**KETCHUM FIRE STATION DESIGN REVIEW  
STAFF REPORT UPDATE  
KETCHUM PLANNING AND ZONING COMMISSION  
SPECIAL MEETING OF FEBRUARY 24, 2020**

**PROJECT:** Ketchum Fire Station

**FILE NUMBER:** P20-013

**APPLICATION:** Design Review

3D PERSPECTIVE

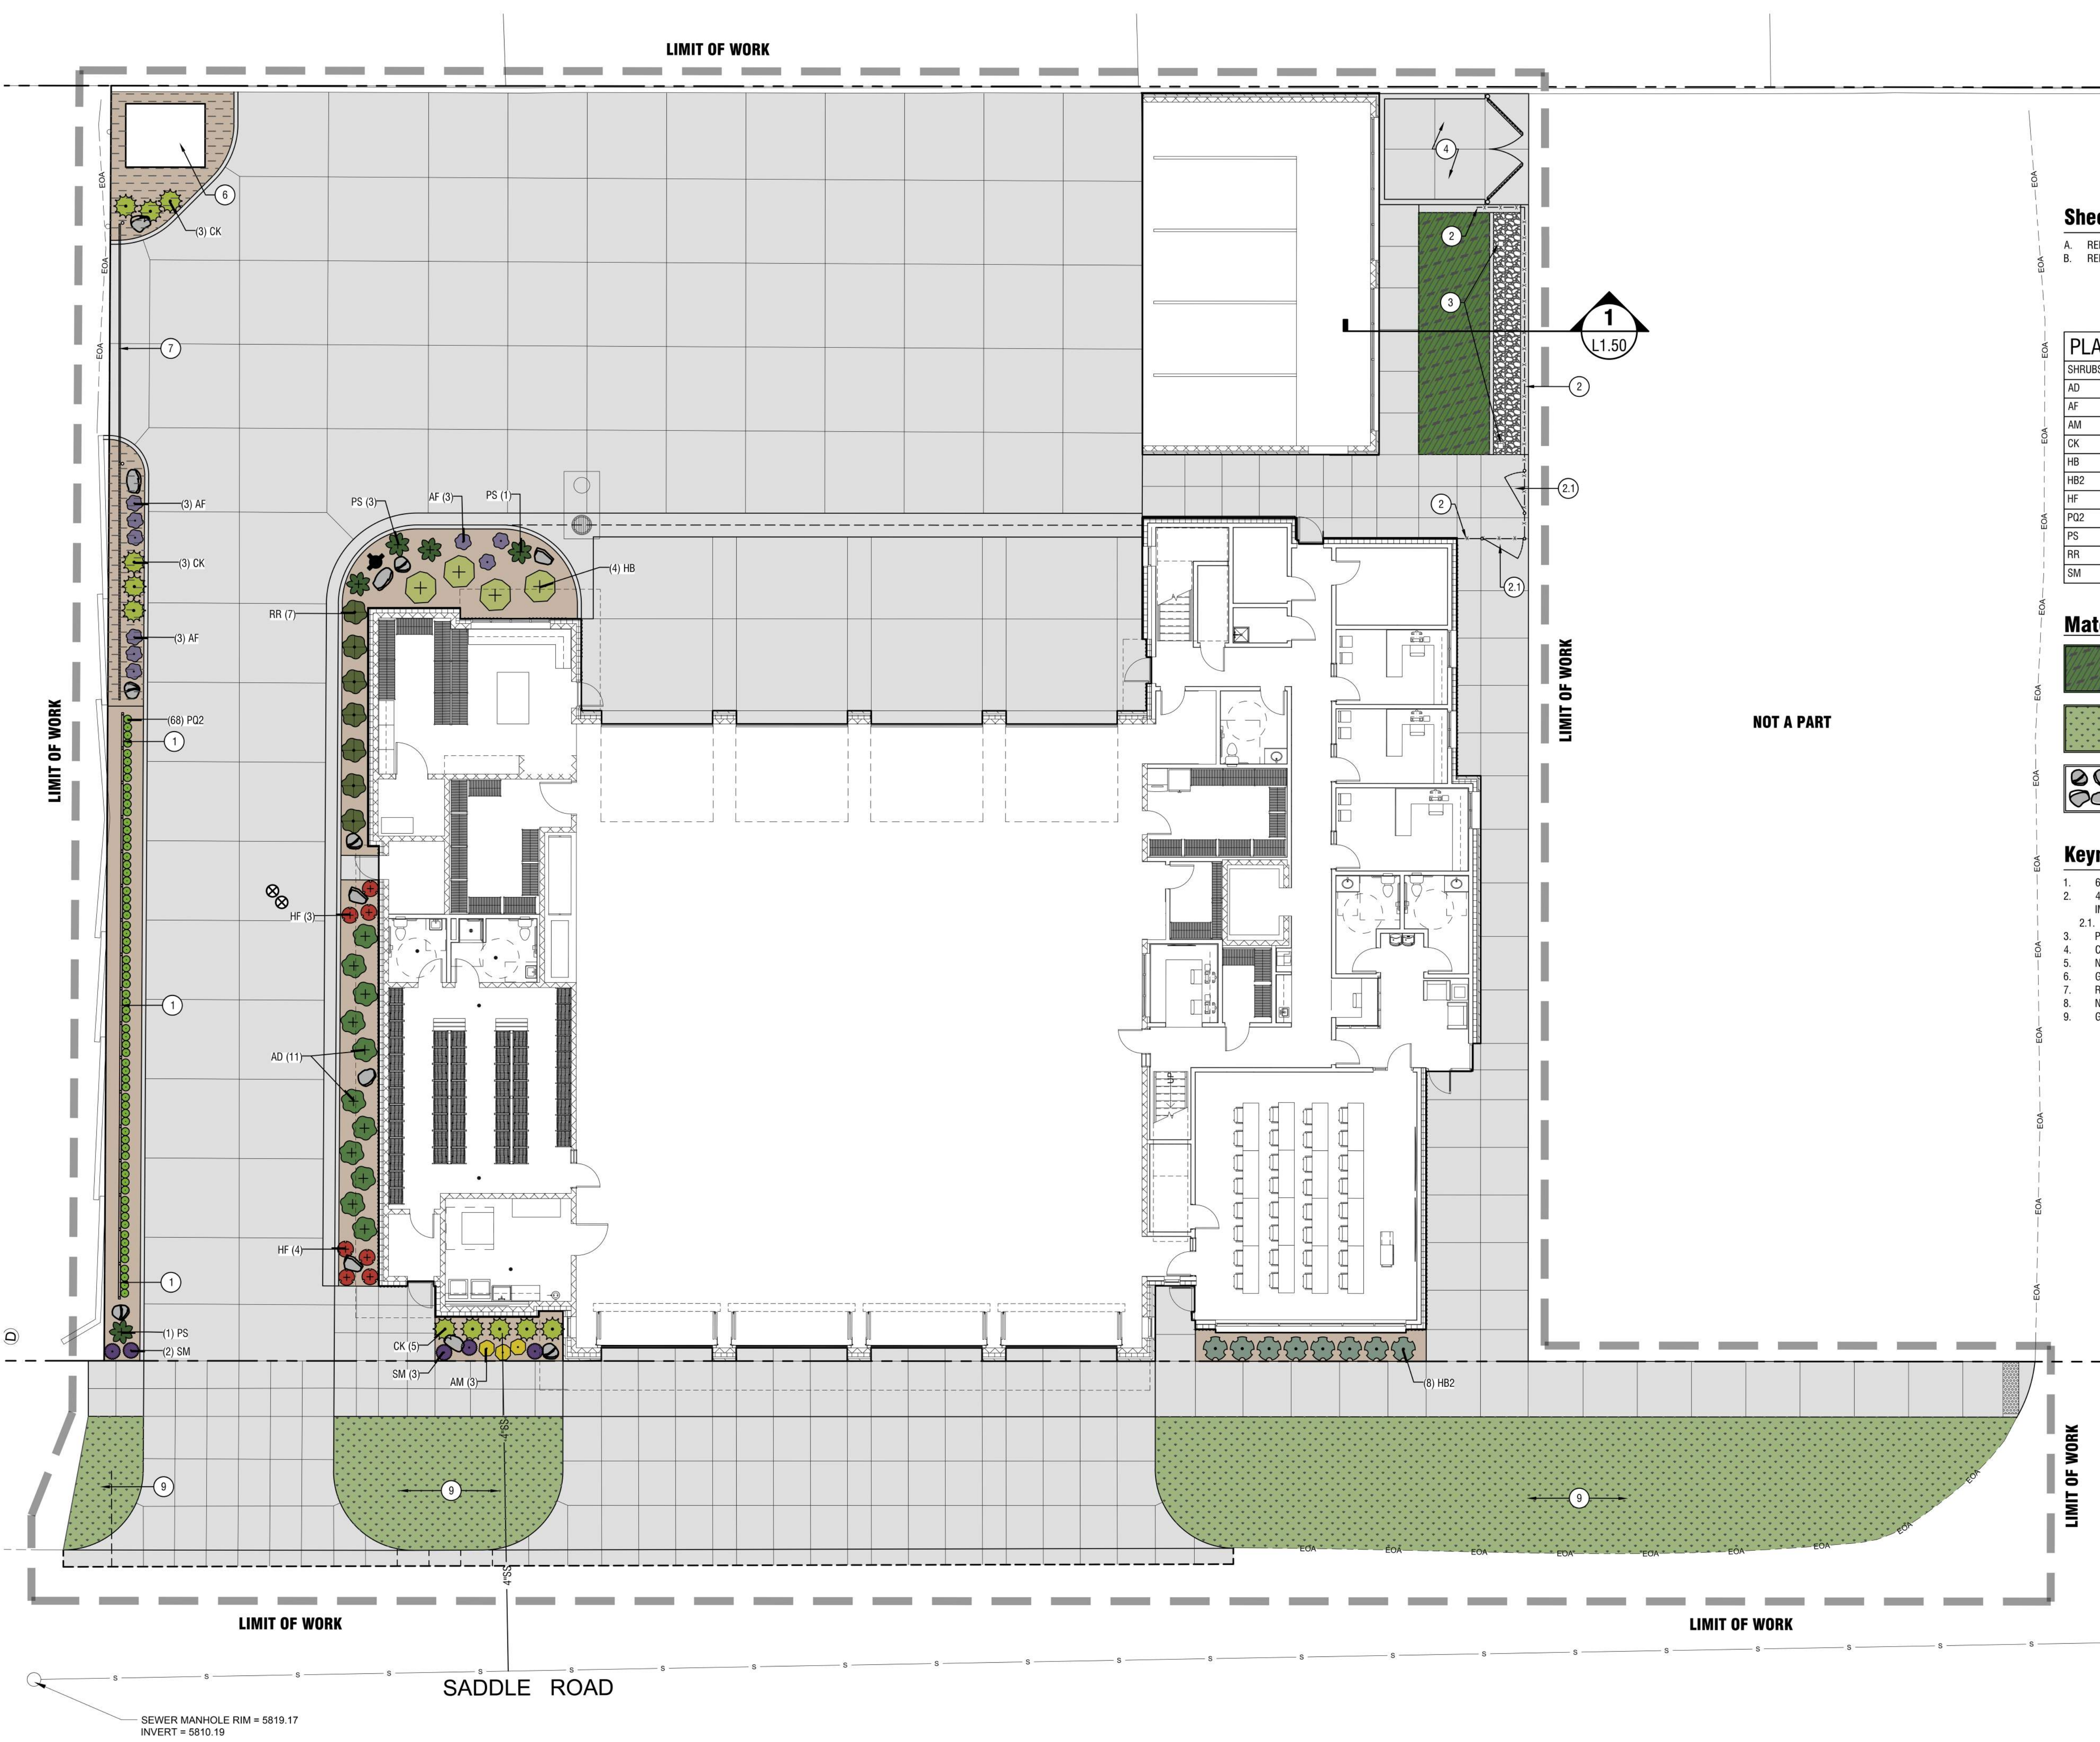
- A revised perspective to reflect the proposed design and landscaping. (Attachment A)

## ATTACHMENT C

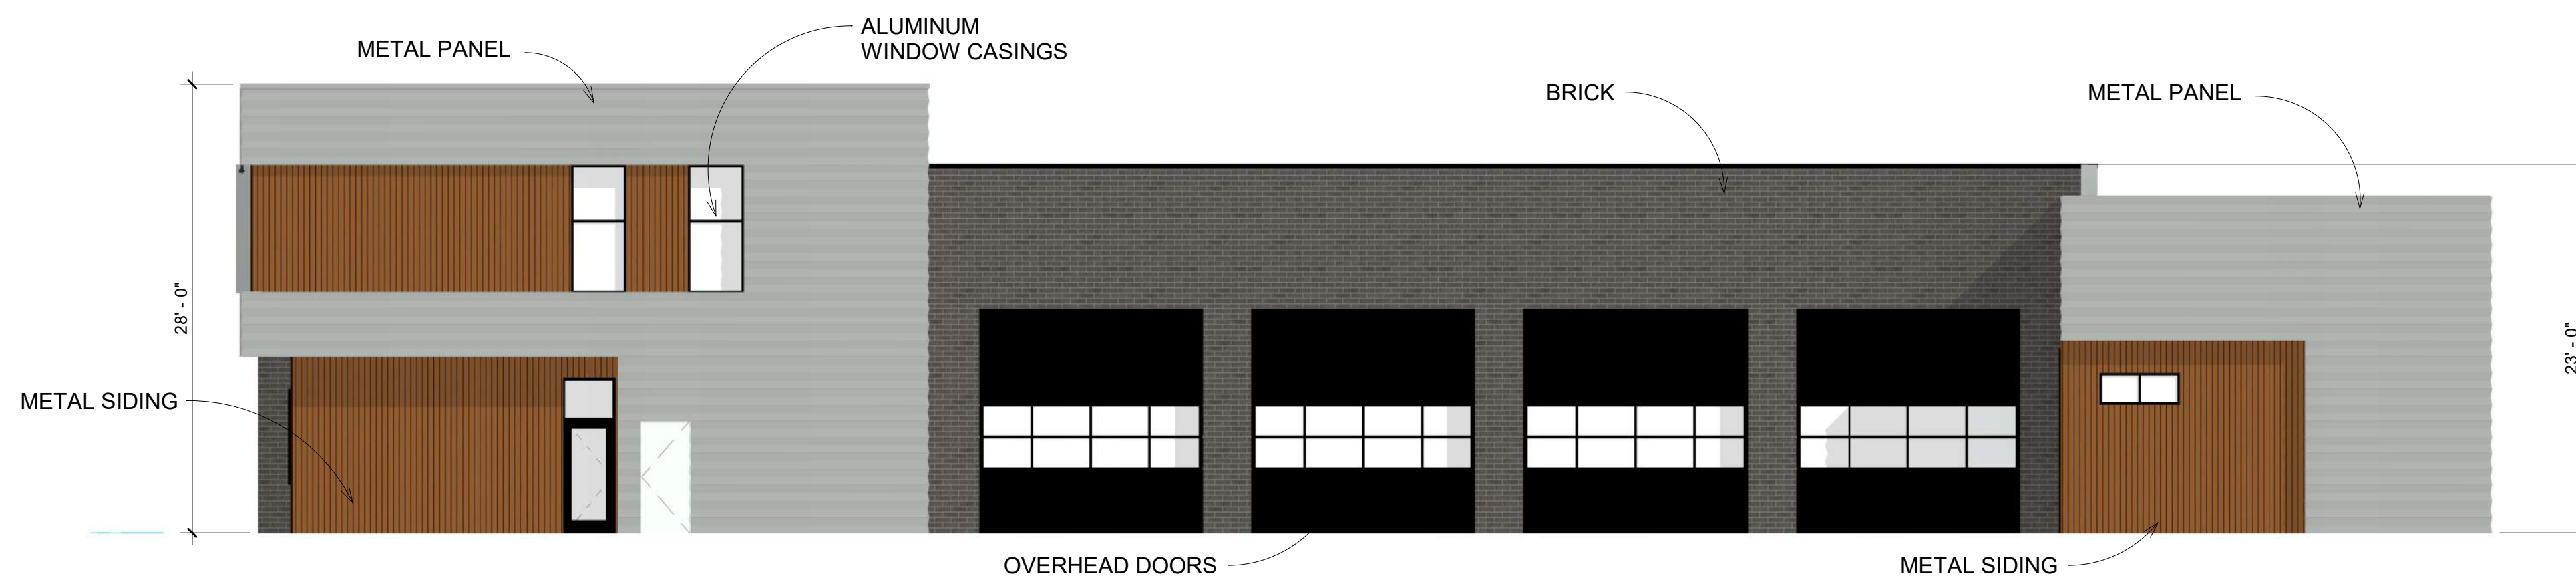
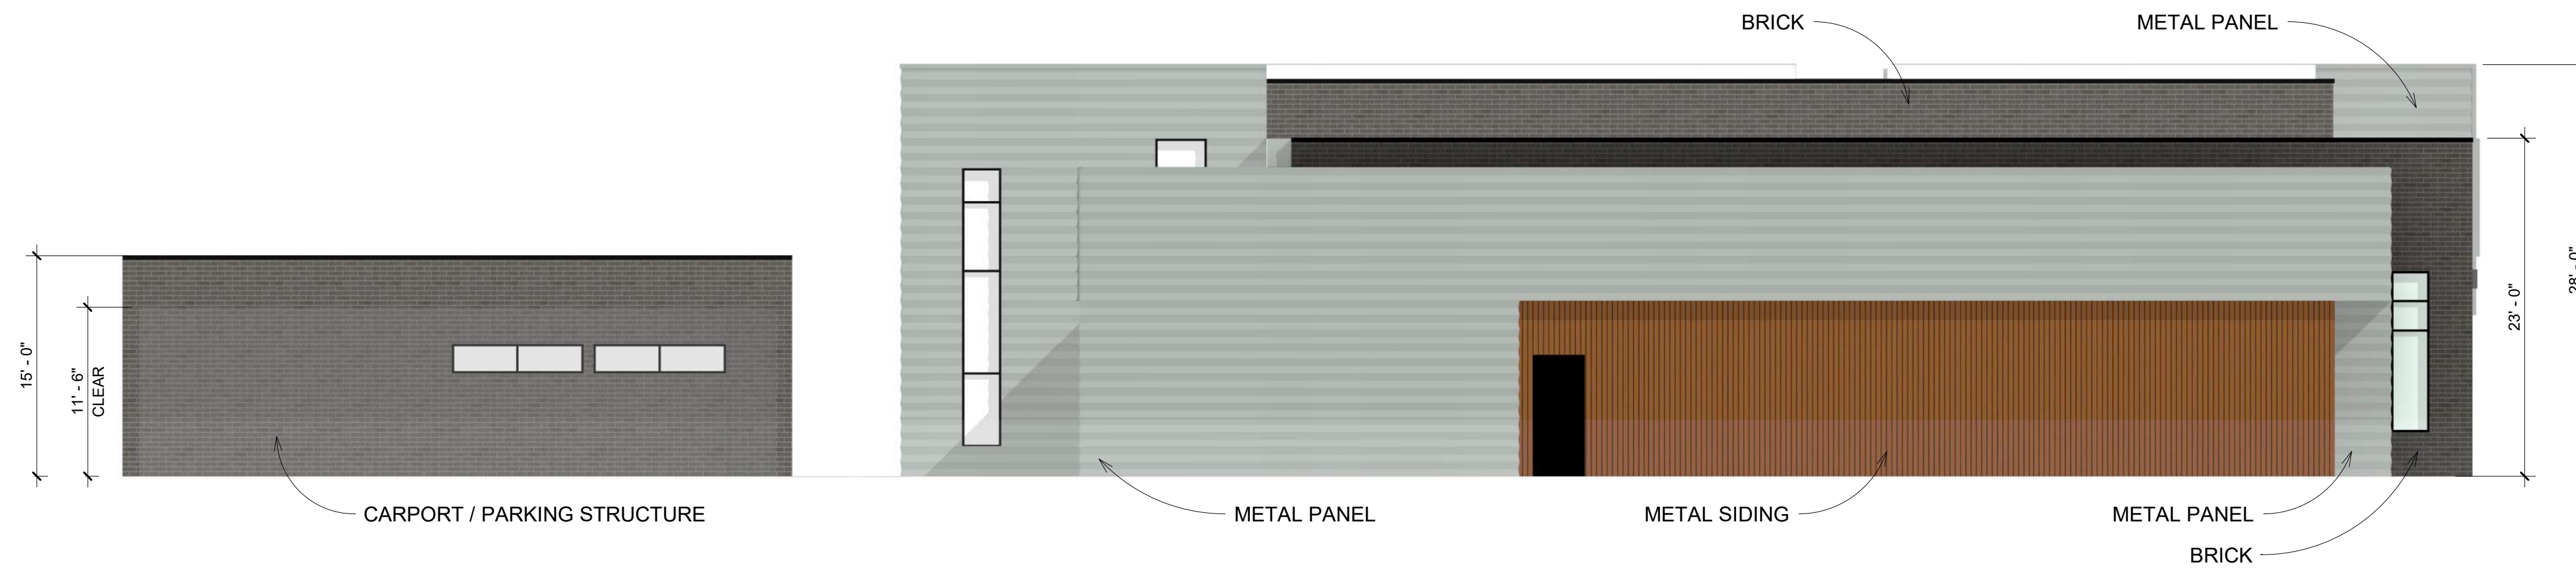
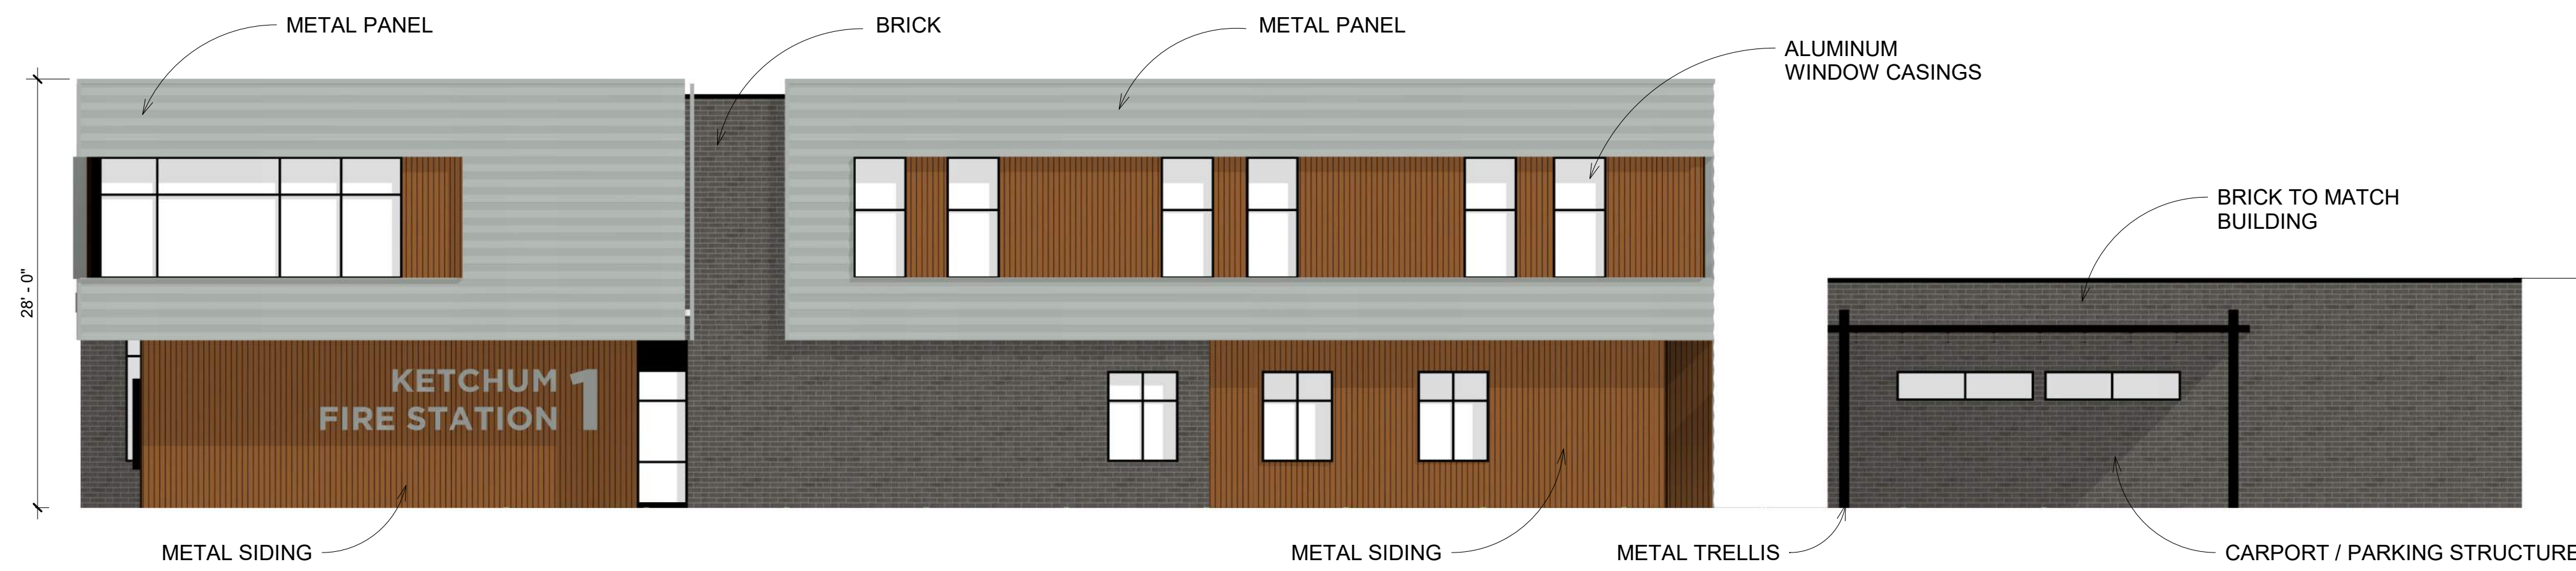
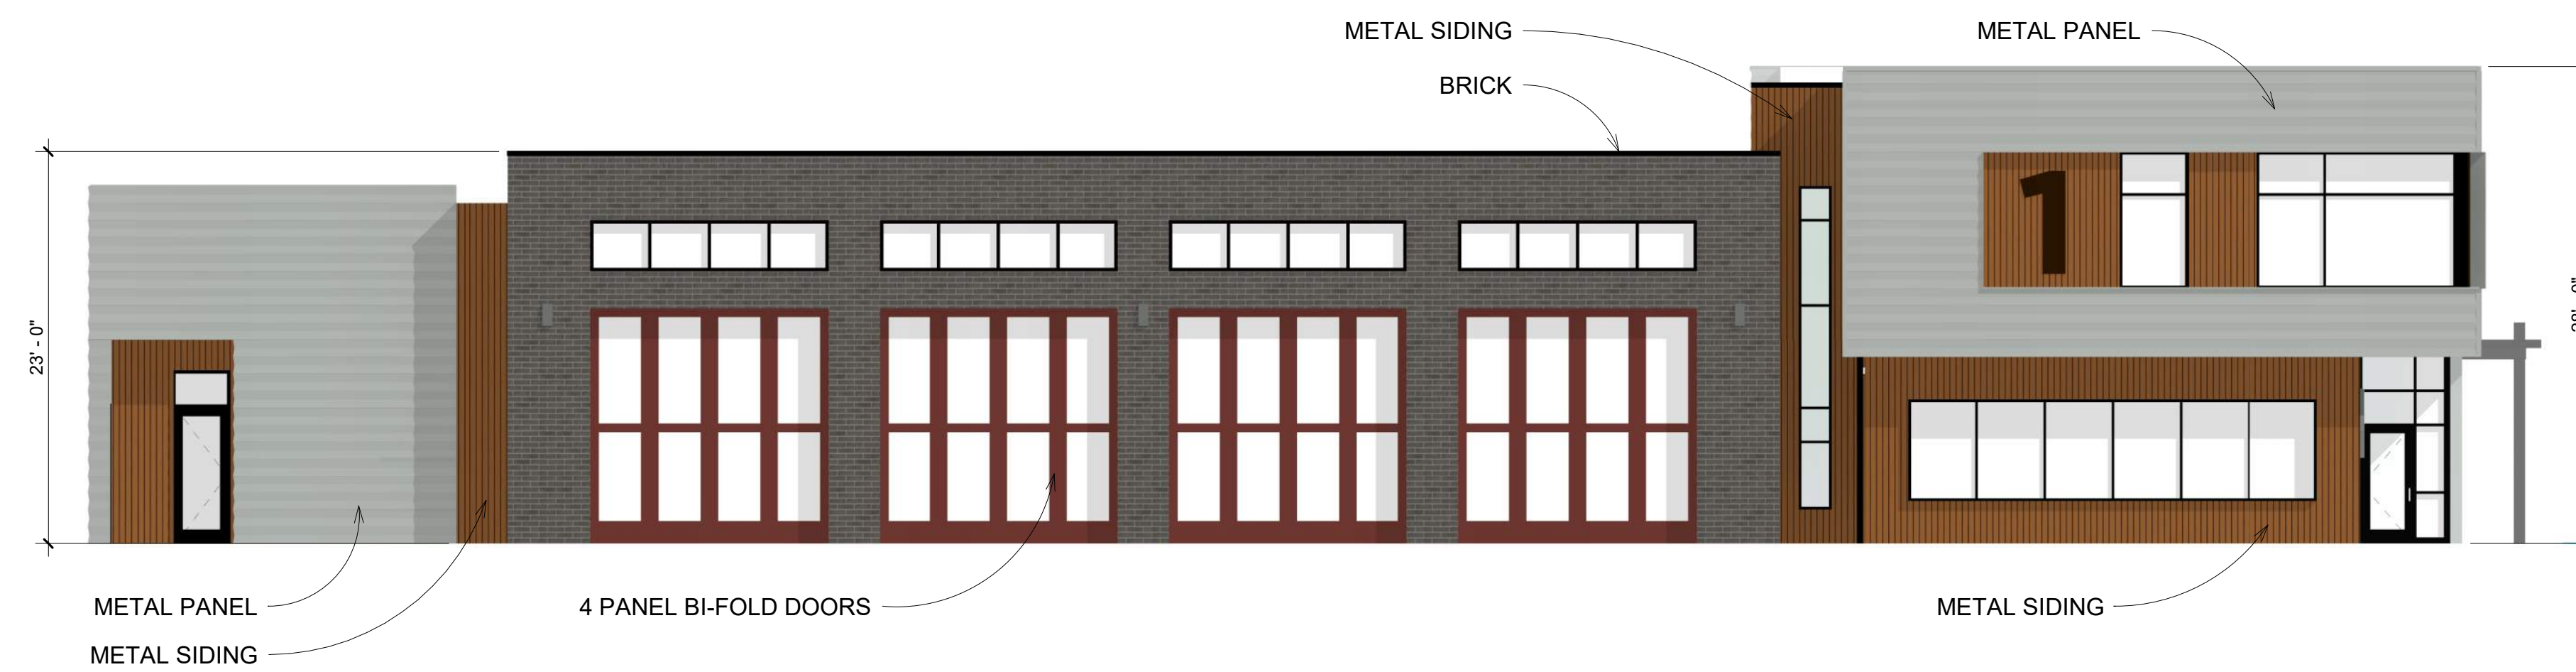
- Revised elevation and floor plans showing the height of the rear carport and removal of a window at rear elevation of the project (Attachment C)

Figure 1. Fire station warning signs with border flashers or beacons.<sup>3</sup>

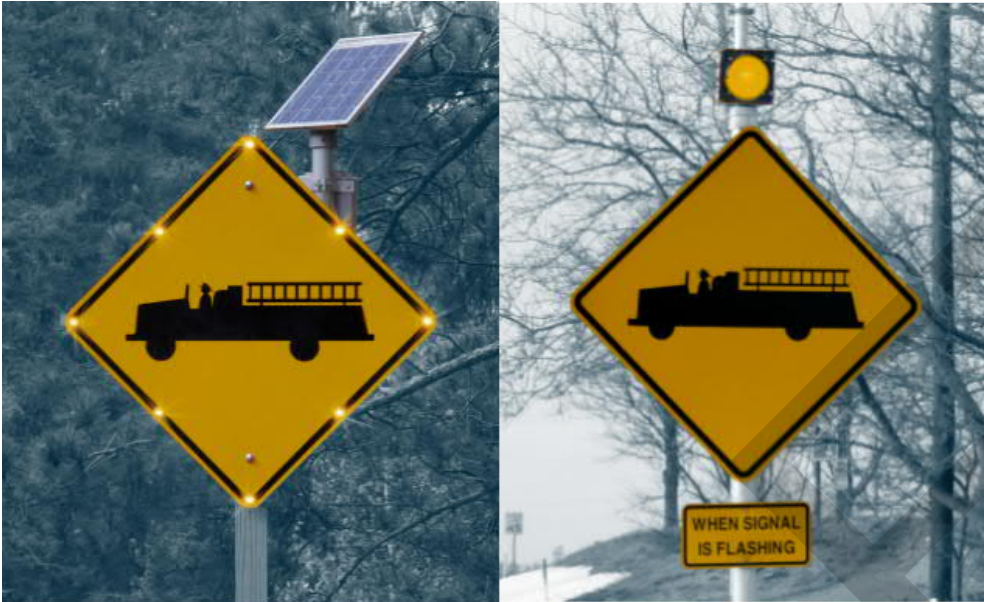
- A system can be installed that includes Fire Station Warning signs (W11-8) with flashing borders and/or flashing beacons to be activated when an emergency vehicle is leaving the fire station (see Figures 1 and 2). The signs would be deployed in strategic locations (such as trail crossings, locations near the Big Wood School or the YMCA, near transit stops, and on Saddle Road and Warm Springs Road, see Figure 3) that would alert pedestrians and bicyclists to the presence of an emergency vehicle.<sup>1</sup> Smaller signs are recommended for pedestrian/bicyclist applications.
